REQUEST FOR INFORMATION

Project Name: KINDRED RESORT

Hardscapes Snowmelt Insulation

Kindred Resort @ Keystone
RFI-01245 Revision 0
response issued_04/26/2024

SNOWMELT PAVER PIPING DIAGRAM
 NO SCALE

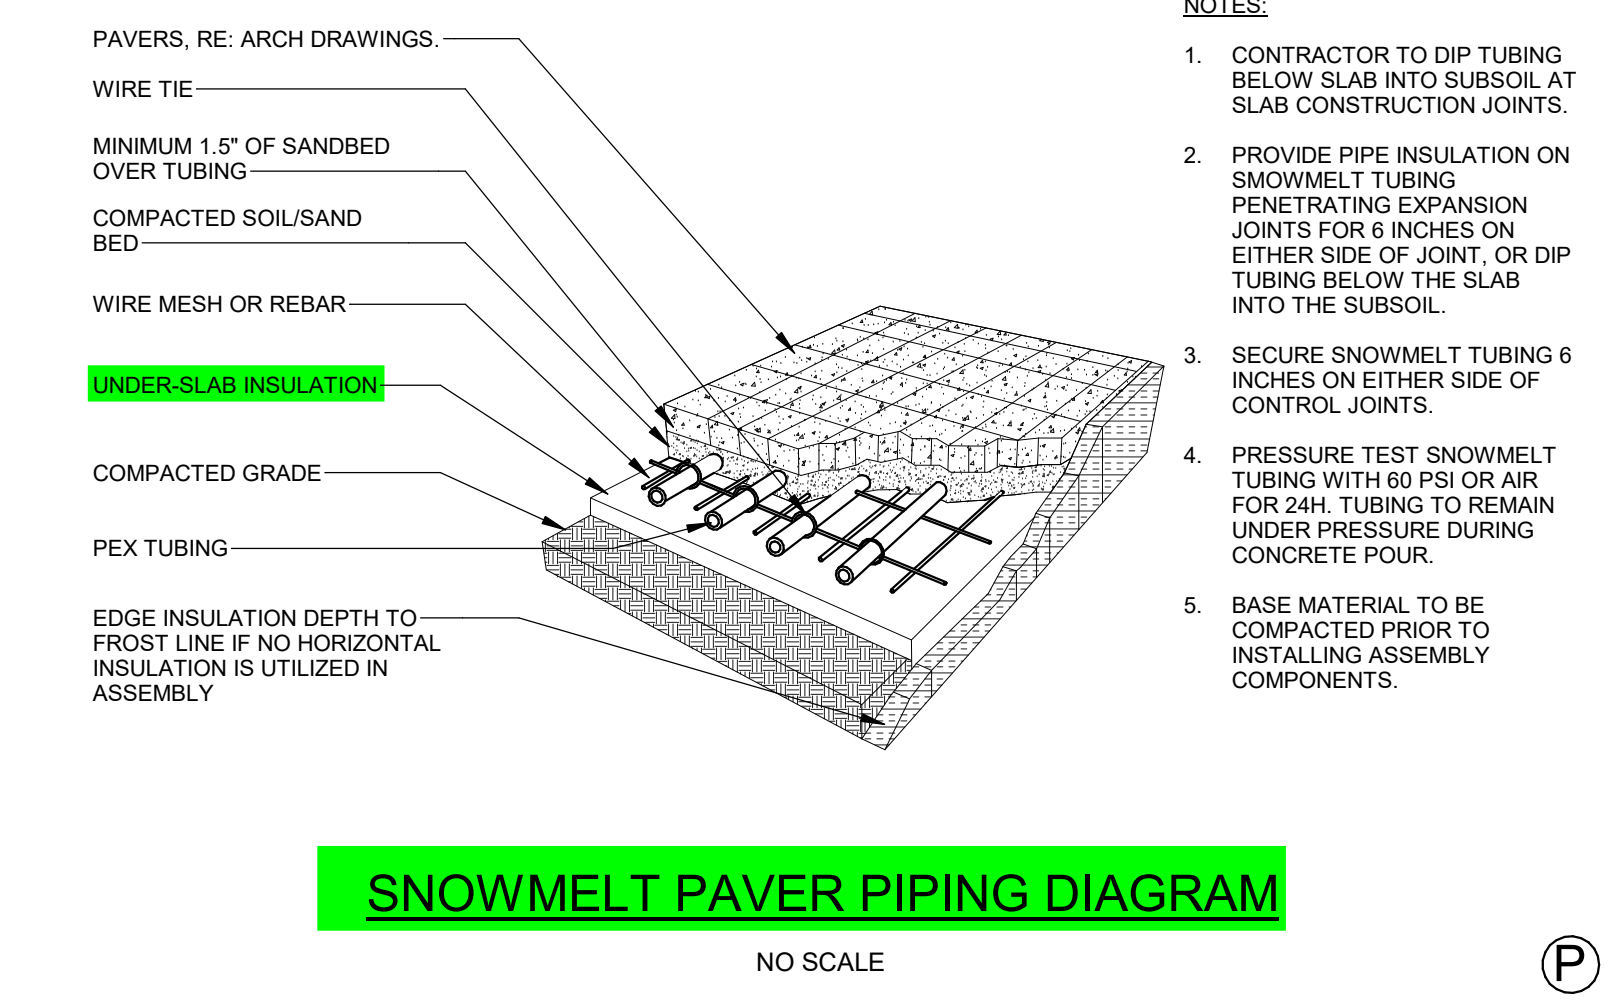
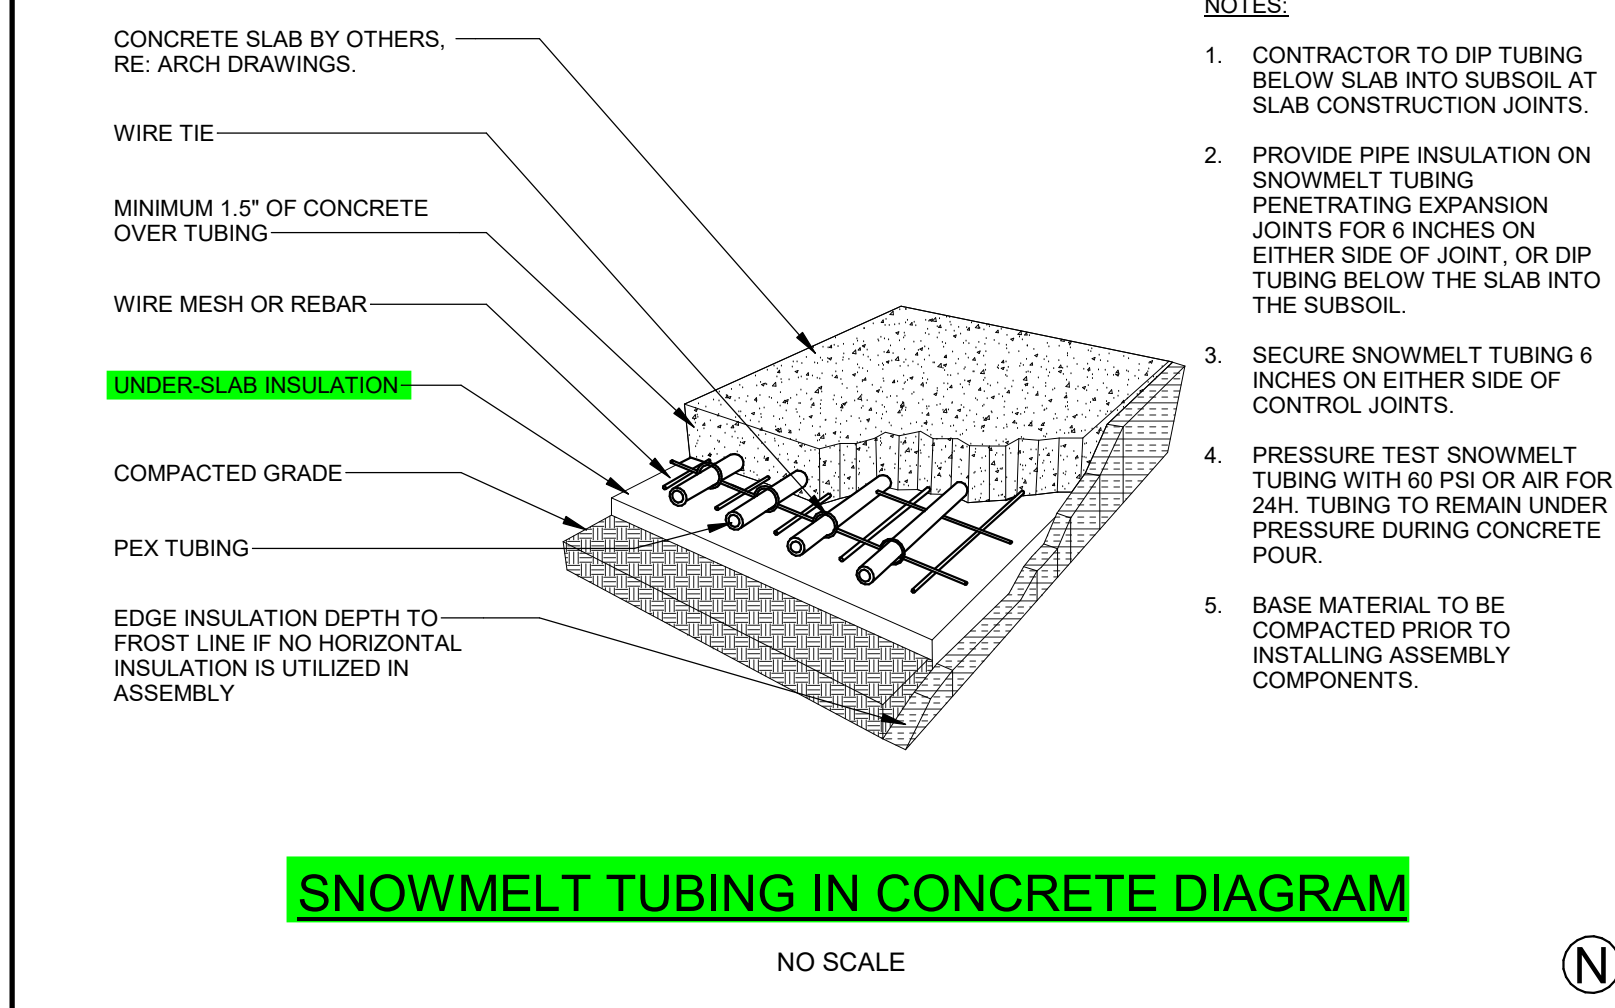
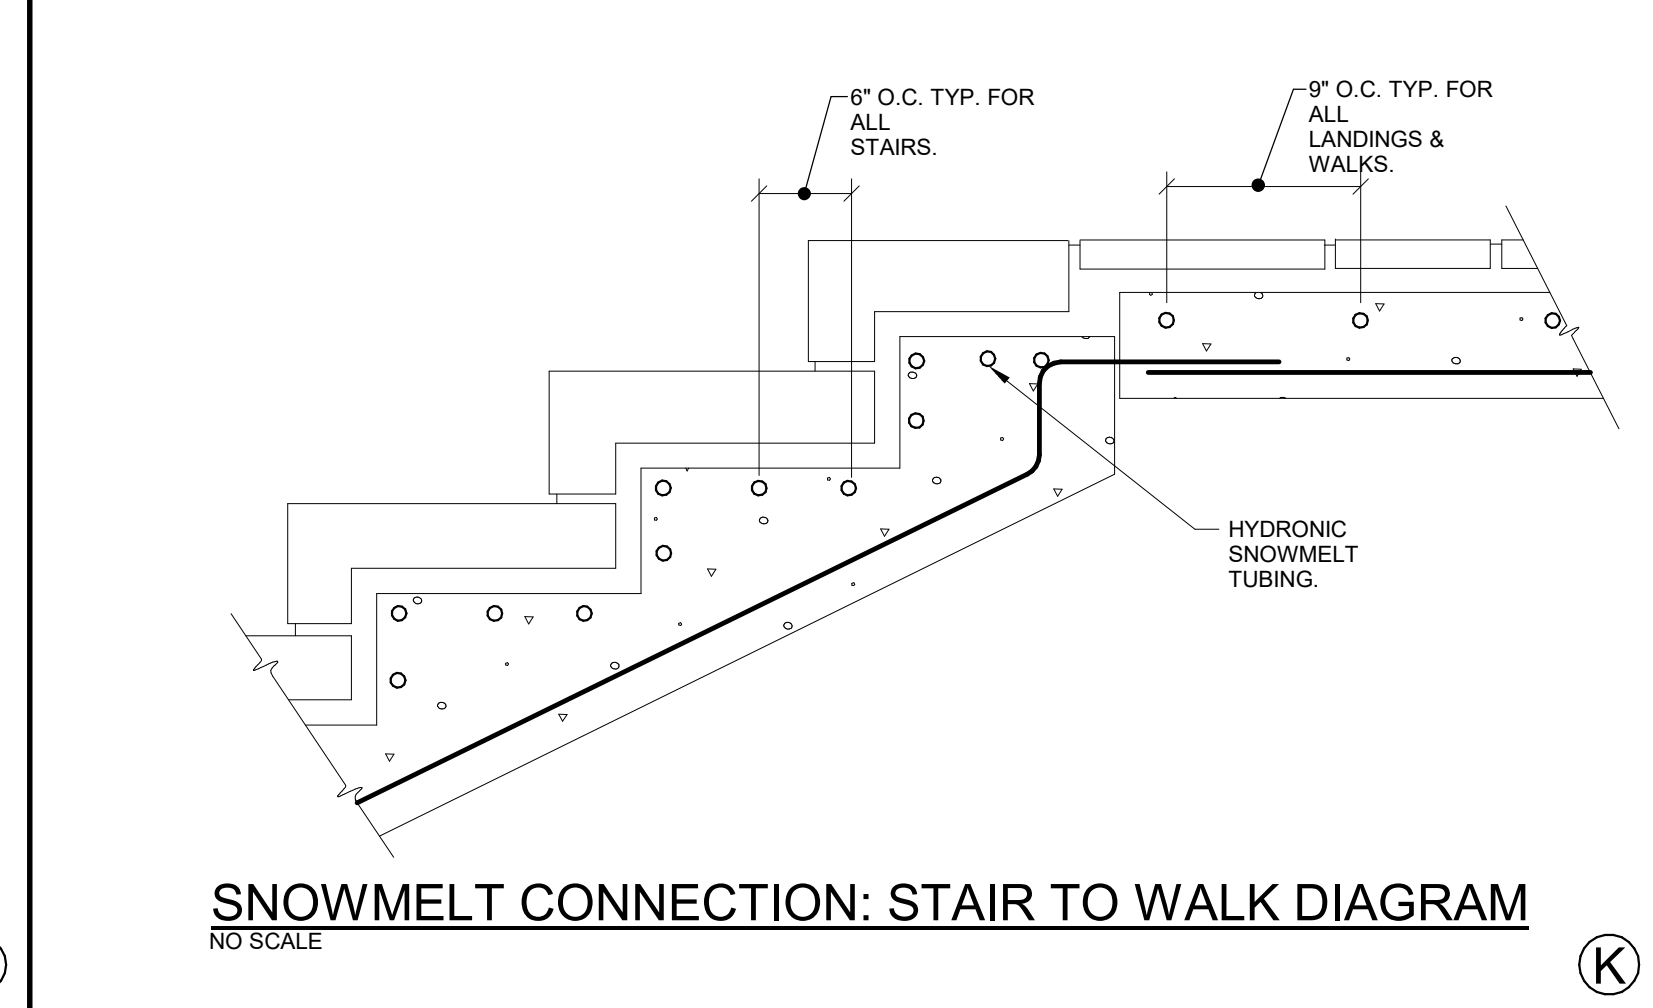
[Submitted: 4/22/2024 by Elliot Weiland, PCL Construction Services, Inc. Rev #0]
 Mechanical diagrams N & P for site snowmelt are shown on M-702 with underslab insulation required. Civil details on C-501 and C-502 do not typically show any foam under snowmelted pavement or curb and gutter.
 The snowmelt design was produced with 2" of rigid insulation.
 Insulation was assumed to be 25 PSI for pedestrian locations and 50 PSI for traffic rated locations per basis of GMP.
 1) Please confirm that 2" of rigid foam under all snowmelted concrete paving and snowmelted pavers is acceptable to Civil.
 2) Please confirm 25 PSI for pedestrian locations and 50 PSI for traffic-rated locations is acceptable.
 3) Please confirm that all top of grade at concrete paving and curb and gutter locations should be cut by an additional 2" to accommodate for the required foam.

BG's response:
 Regarding item #1, we take no exception to Tetra Tech's response.
 Insulation is absolutely required below walking surfaces.

We always recommend insulation below driving surfaces, but insulation can be omitted under driving surfaces. The pros/cons of this are:

- Cons to insulation below driving surfaces:
 Traffic-rated insulation can be expensive
 Can make the roadway more amenable to potholes if insulation caves
 Snowmelt will still melt the snow, but will take longer to do so.
- Pros to insulation below driving surfaces
 Snowmelt will melt the snow much faster
